NATIONAL PRIMARY DRINKING WATER REGULATIONS FOR LEAD AND COPPER

Proposed Minor Revisions -- Annotated Flow Charts

National Primary Drinking Water Regulations For Lead and Copper Flow Charts Annotated to Show Effect of Proposed Revisions

January 31, 1996

OPTIMAL CORROSION CONTROL TREATMENT (141.82)

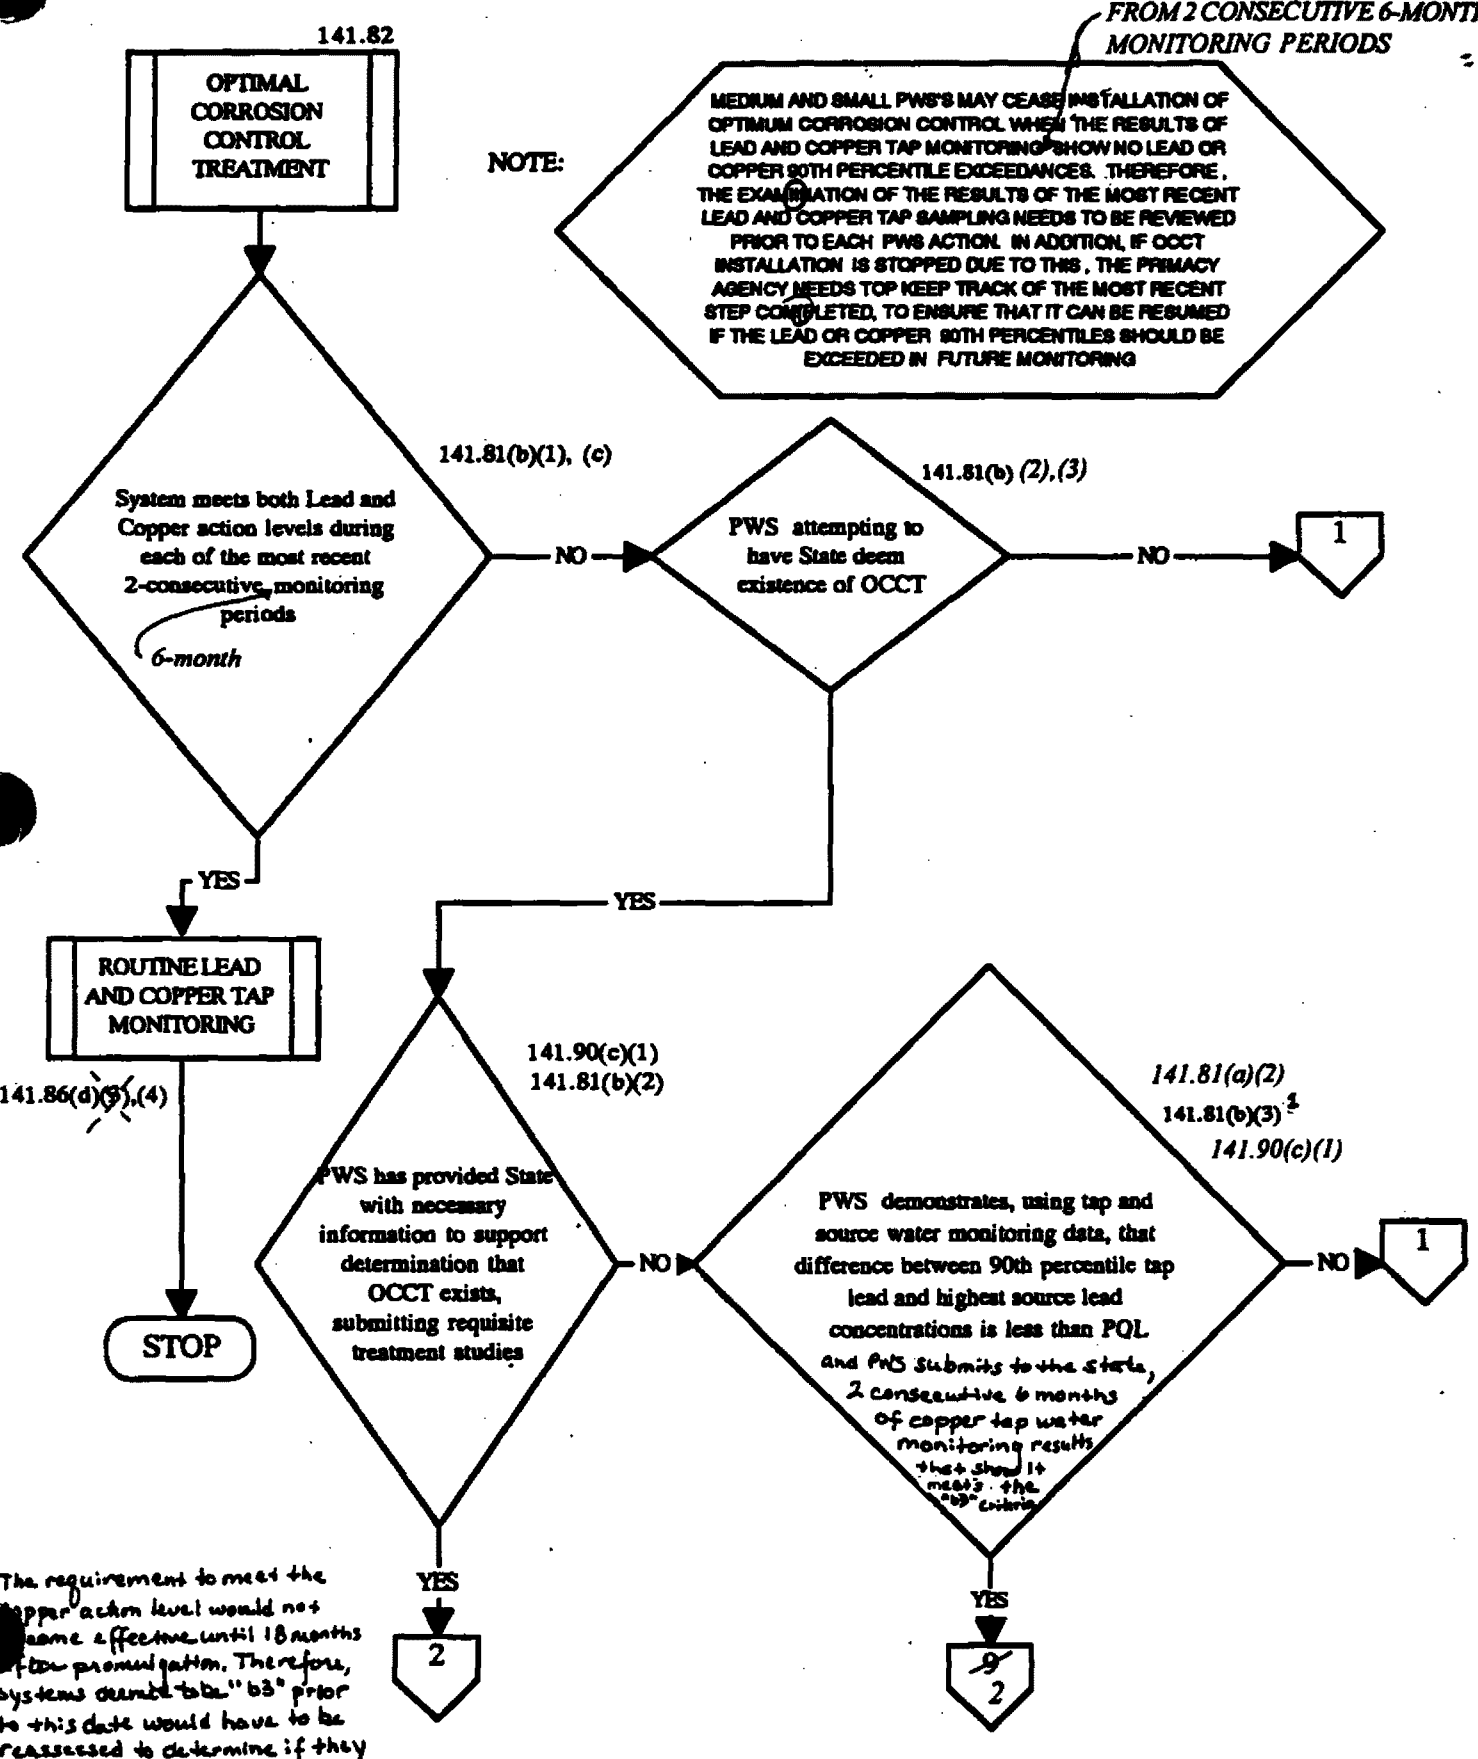
1 The requirement to meet the copper action level would not become effective until 18 months after promulgation. Therefore, systems deemed to be "b3" prior to this date would have to be reassessed to determine if they meet the copper criterion.

OPTIMAL CORROSION CONTROL TREATMENT (141.82)

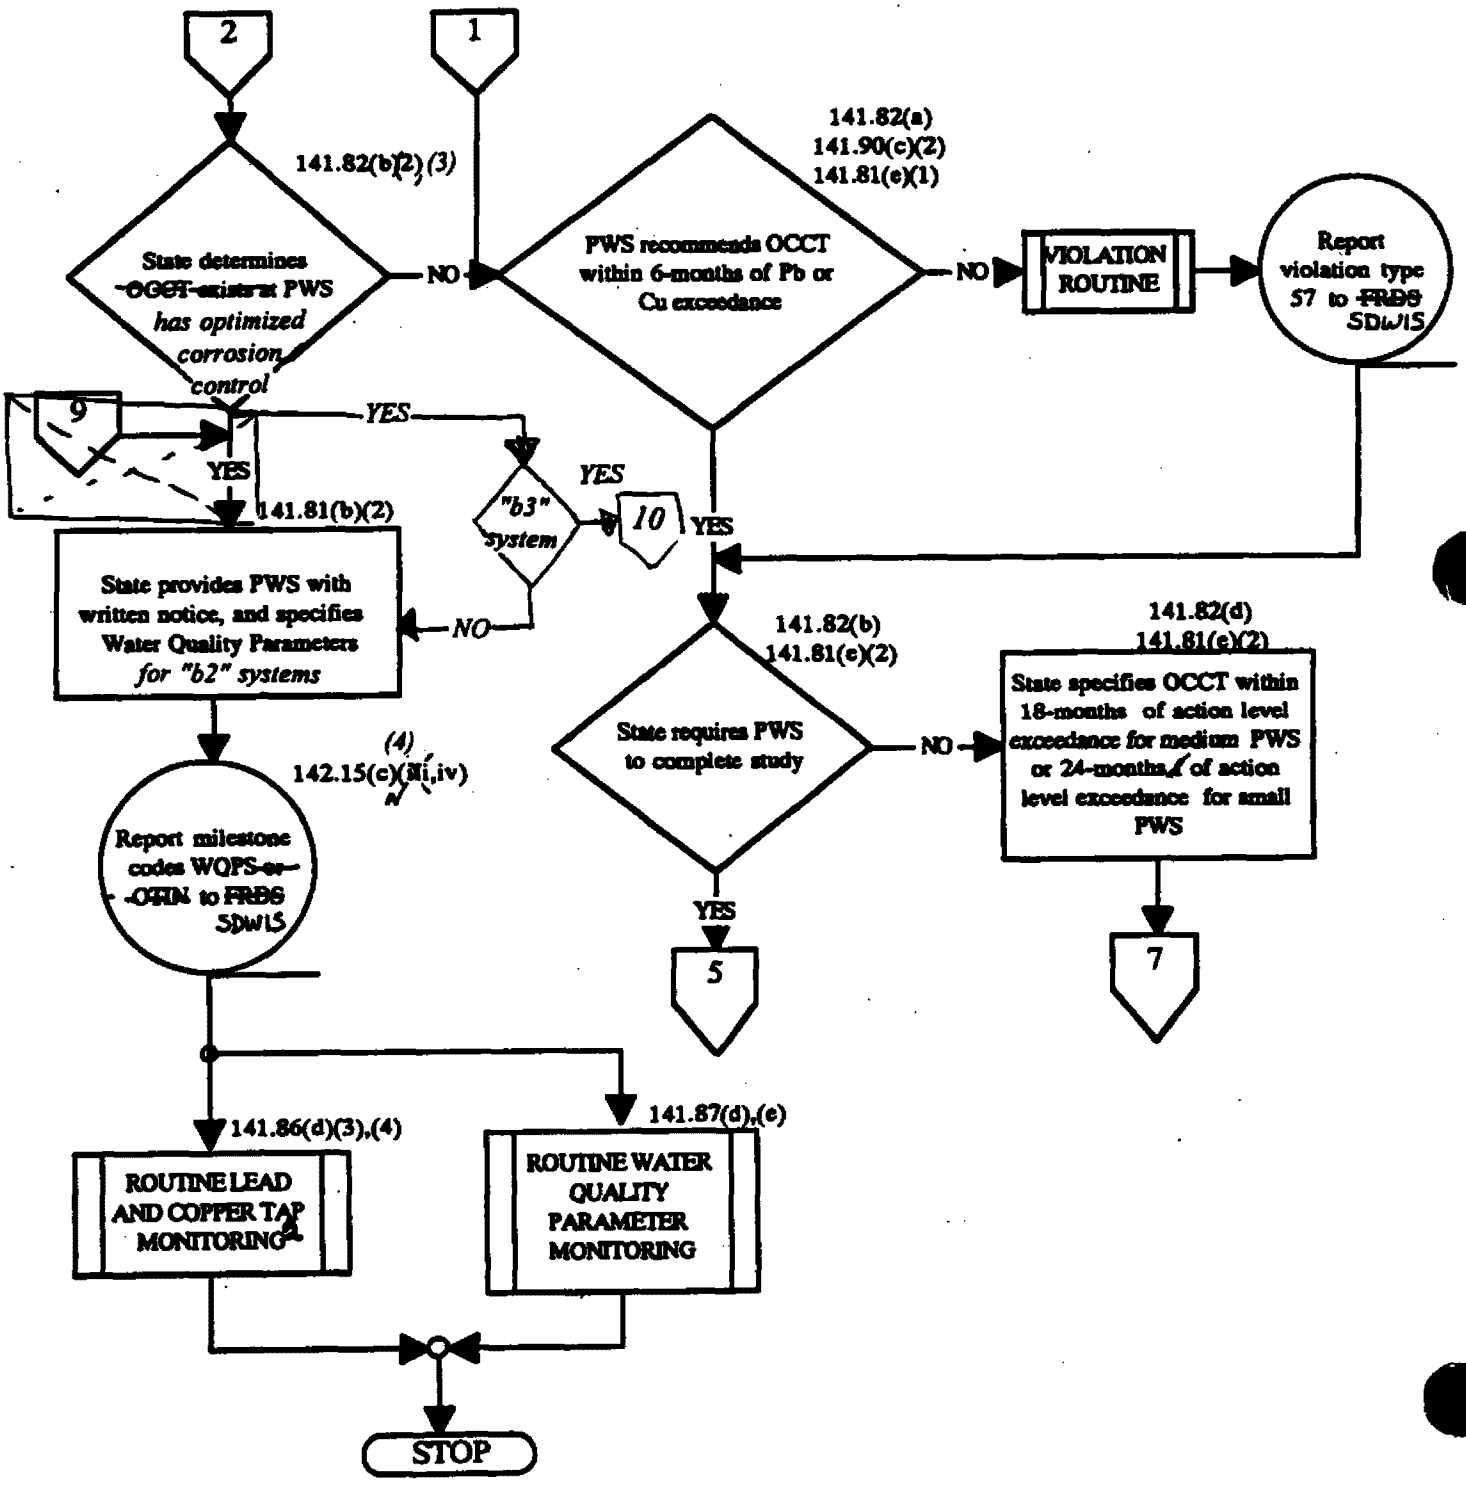
Note: *This flowchart shows the intention of the current rule that systems optimizing corrosion control under 141.(b)(2) and 141.(b)(3) (i.e., "b2" and "b3" systems) conduct lead and copper tap monitoring after initial monitoring, and that "b2" systems continue WQP monitoring (if appropriate); however, the rule language did not explicity require this. The proposed revisions included language which specifically requires this continued monitoring.*

* The proposed LCR revisions add a new 141.86(d)(4)(v) that would allow accelerated lead and copper tap monitoring. For more details, refer to the Routine Lead and Copper Tap Monitoring ≤ 50,000 flowchart.

LEAD AND COPPER RULE - FLOW CHART
PUBLIC EDUCATION (141.85)
ALL SYSTEMS SIZES

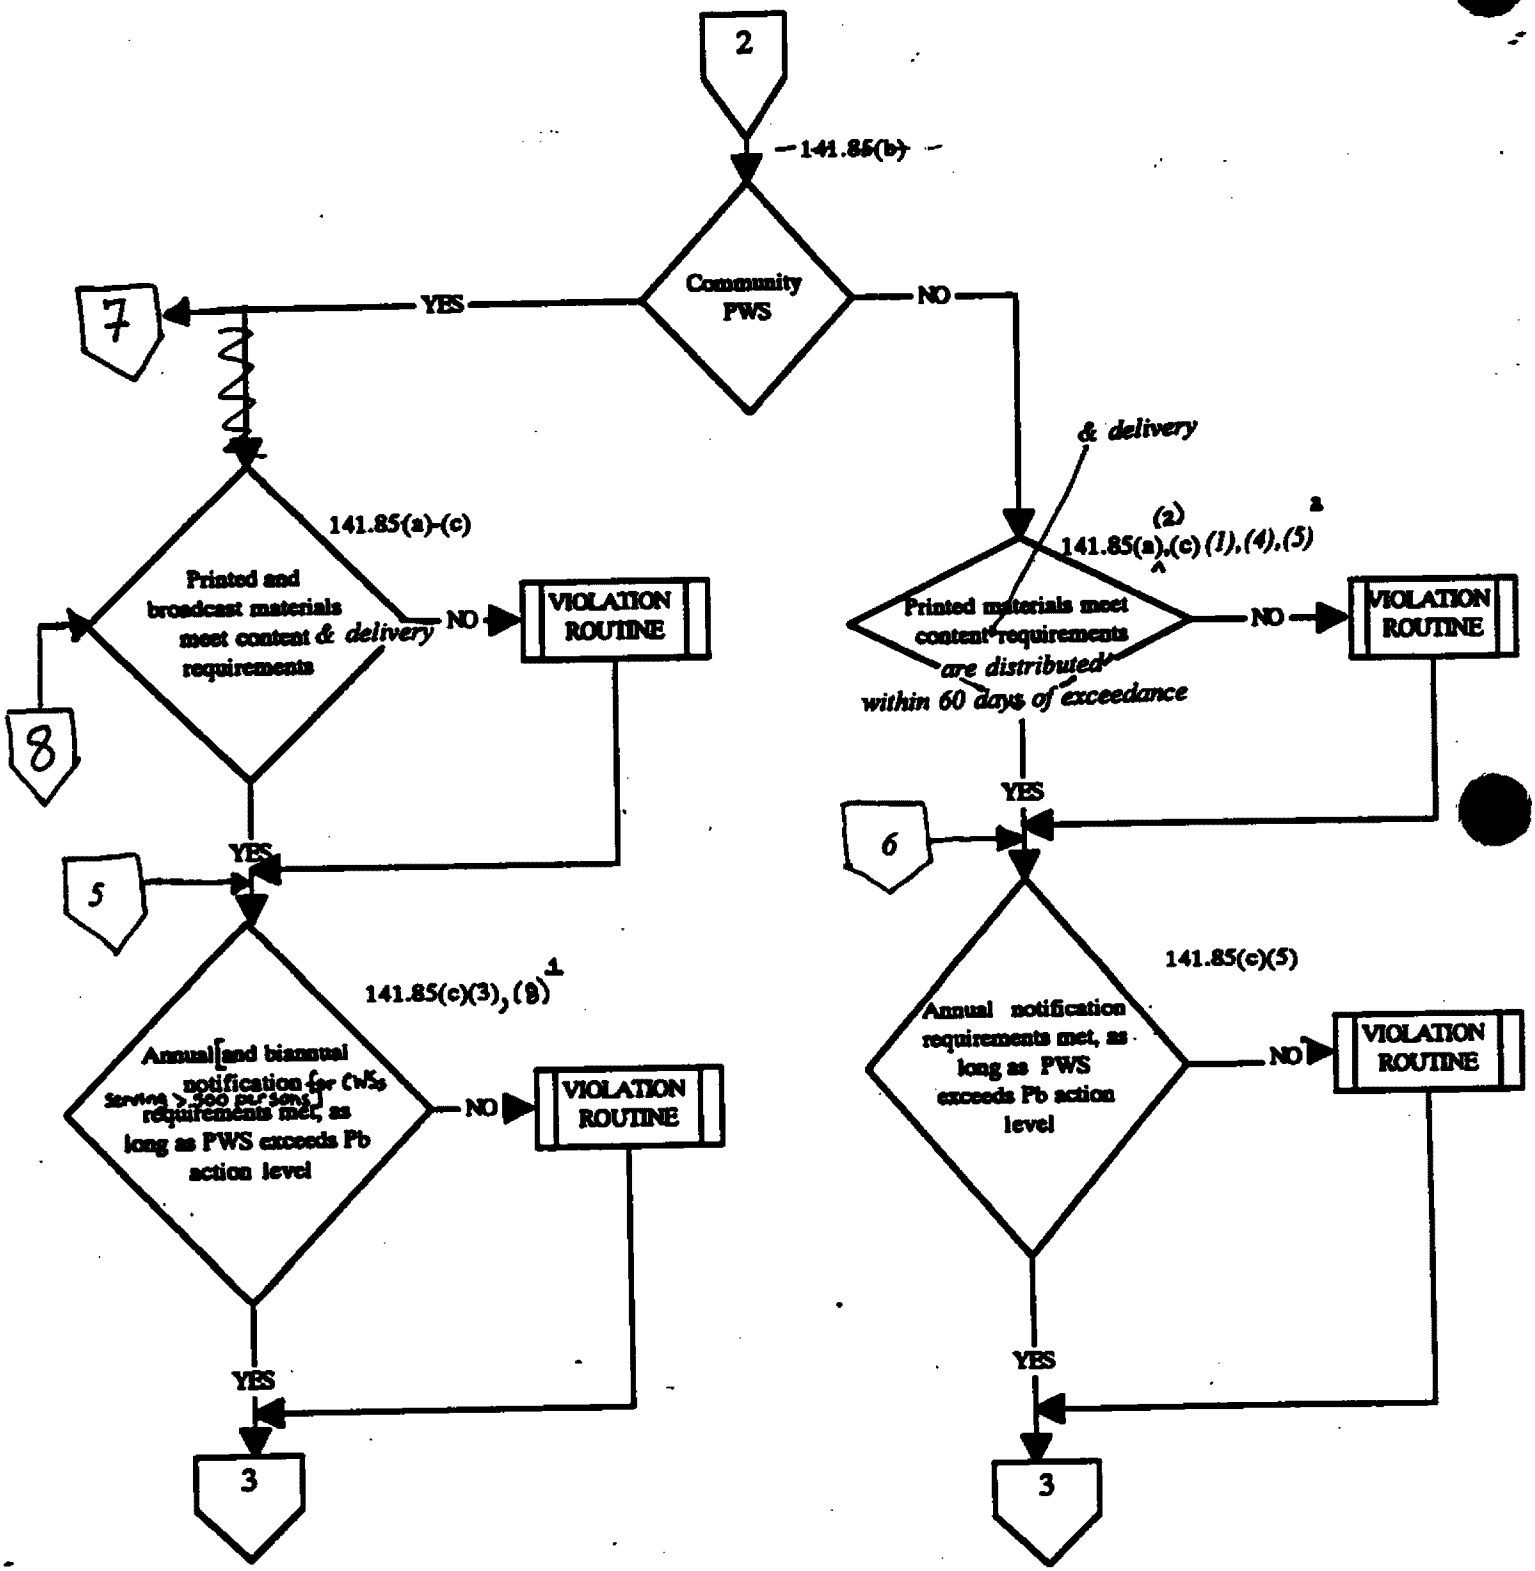
1 The proposed requirements under 141.85(c)(8) apply only to CWSs serving ≤ 500 people.

2 NTNCWSs have the option of using the public education language found at 141.86(a)(2)(i), (ii), & (iv).
